SUNDRY NOTICES AND REPORTS ON WELLS
Do not use this form for proposals to drill or to re-enter an abandoned well. Use Form 3160-3 (APD) for such proposals.Lease Serial No
NM-13279

☐ Oil Well☒ Gas Well☐ Other8. Well Name and No
BANDIT 15 FEDERAL COM #2

BANDIT 15 FED COM #2
API # 30-025-37231
SECTION 15-20S-33E
TEAS FIELD
LEA COUNTY, NM

Bandit 15 Federal Com #2
Three Rivers Operating Company
30-025-37231
July 26, 2011
Conditions of Approval

PROPOSED PLUG BACK TO STRAWN

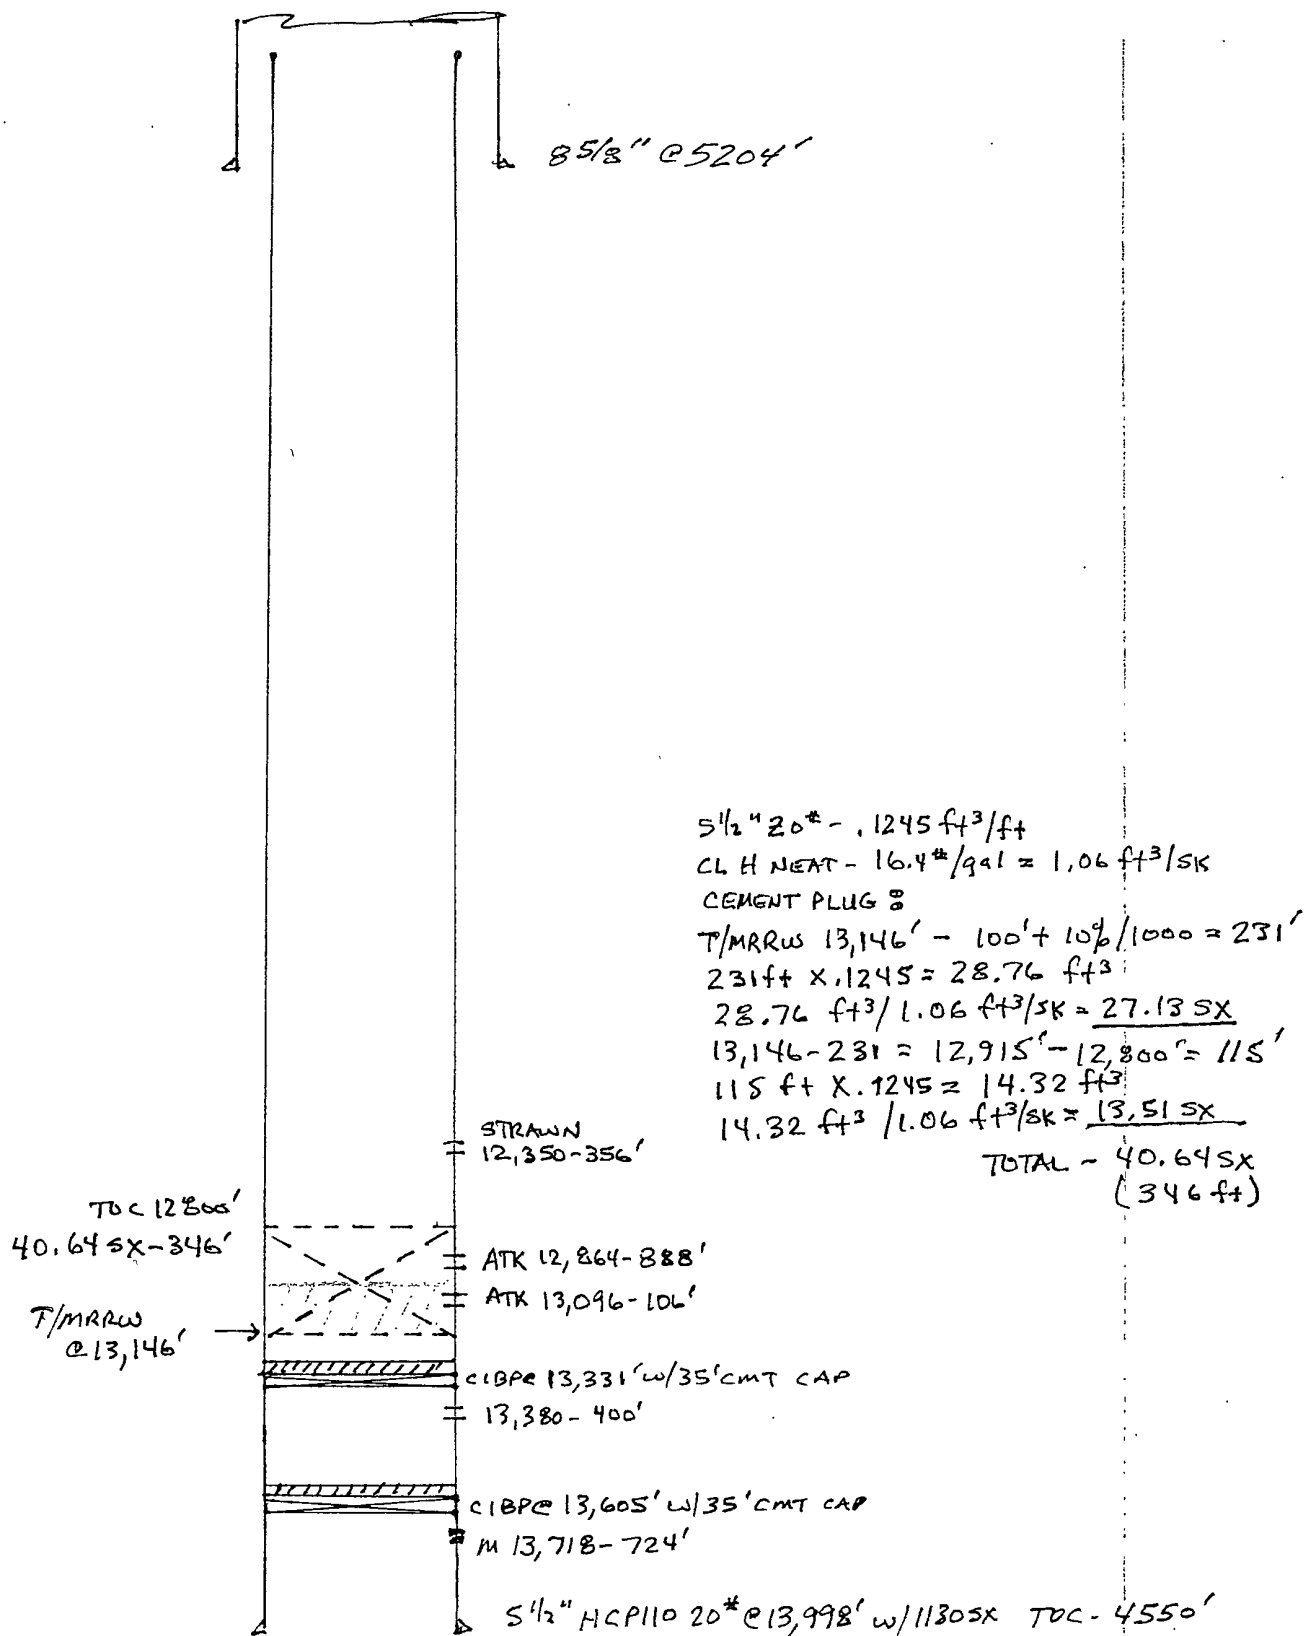
- d) Mud laden fluid shall be circulated into the interval 13296' to 13146' prior to placing the cement slurry from 12800' – 13146'. (Onshore Order 2.III.G.9)

- e) BLM to witness tags of original PBTD at 13296' and new PBTD at 12814' or higher.
- f) Pressure testing of casing shall comply with Onshore Order 2.III.B.1.h.

BOP and Flare Stack Drawing

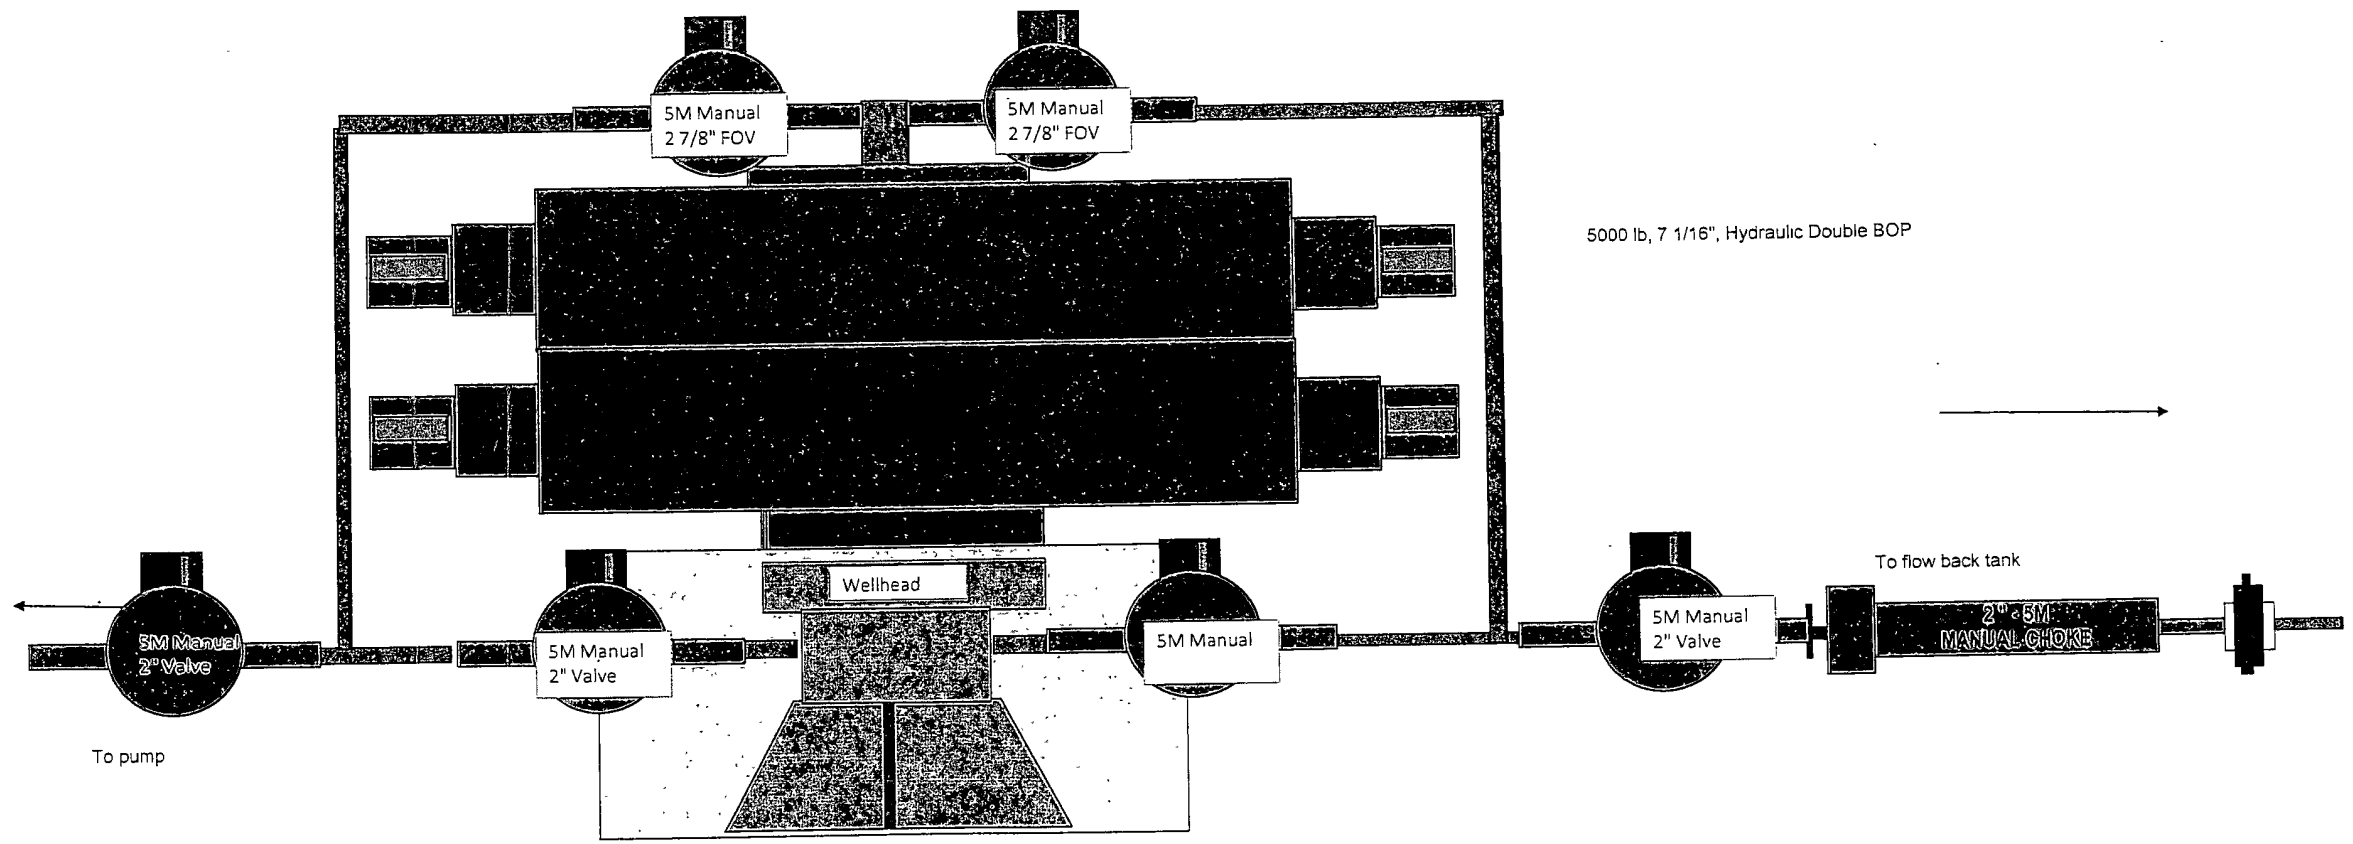
- a) Surface disturbance not to exceed originally approved pad without prior approval.
- b) Closed Loop System to be used.
- c) **A minimum of a 3000 (3M) BOP to be used. All blowout preventer (BOP) and related equipment (BOPE) shall comply with reasonable well control requirements. A two ram system with a blind ram and a pipe ram designed for the size of the work string shall be adequate. Tapered work strings will require an additional pipe ram. The manifold shall comply with Onshore Oil and Gas Order #2 Attachment I (2M Diagrams of Choke Manifold Equipment). The accumulator system shall have an immediately available power source to close the rams and retain 200 psi above pre-charge. The pre-charge test shall follow requirements in Onshore Order #2.**
